City of Palo Alto Public Safety Building and California Avenue Parking Garage

Final Environmental Impact Report

Prepared by the CITY OF PALO ALTO
Assisted by MIG

DEIR Page 160 (Out of date, underestimates quake probability)

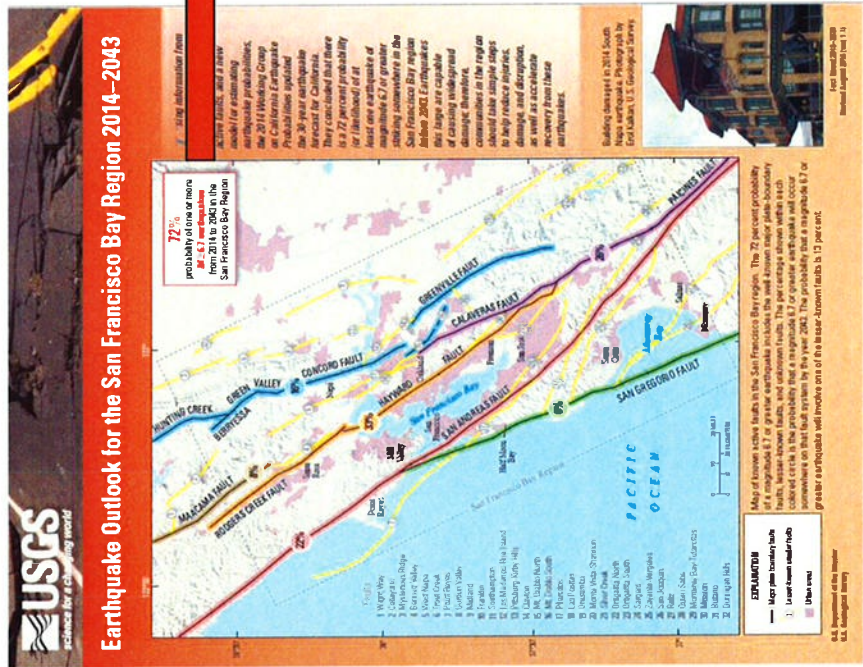
L-8.01 February 25, 2018. Here are the slides I plan to show during the ARB public comments section on the DEIR [this was a March 1, 2018 meeting]. It very clearly spells out some updates needed to the DEIR with regards to earthquake probabilities, magnitude and intensity, using data from the USGS and ABAG.

To me this raises concern whether these mitigations will be adequate? Especially when the building is potentially being under designed for an MMI of only 7.

Response L-5.01: See Response PTC-1.01, which responds to Mr. Hitchings' verbal comments at the January 31, 2018 PTC meeting in reference to Draft EIR chapter 8 (Geology and Soils). As noted in the chapter's introduction, much of the chapter's information is based on a geotechnical investigation that was published in May 2016, approximately one month before the data provided by Mr. Hitchings was published. As recommended by letters L-5 and L-8, the seismic safety discussion on EIR page 8-11 has been updated, as discussed further in Response PTC-1.01.

Response L-8.01: Please see Response L-5.01, directly above.
